概要

この通知は、SBGA パッケージの製品マーキングが変更されることをお知らせするものです。この変更による、フォーム、形状、機能への影響はありません。

ザイリックスは、すべての SBGA パッケージのトップ マークをインクによる印字からレーザーに変更します。

この通知は参照用として、英語版 (XCN14025、バージョン 1.0、2014 年 9 月 8 日リリース) を翻訳したものです。

図 1

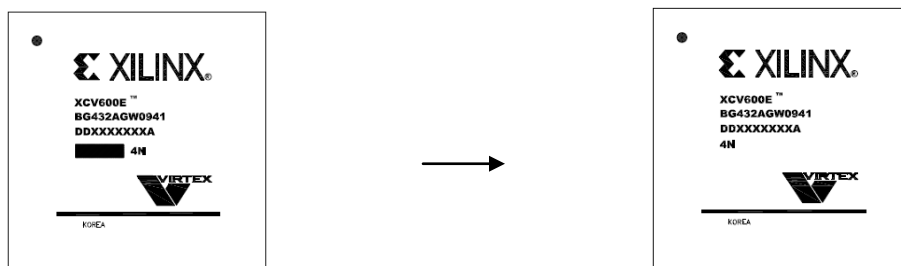
製品マーキングの変更

現在のマーキング (黒インク)

新しいマーキング (レーザー)
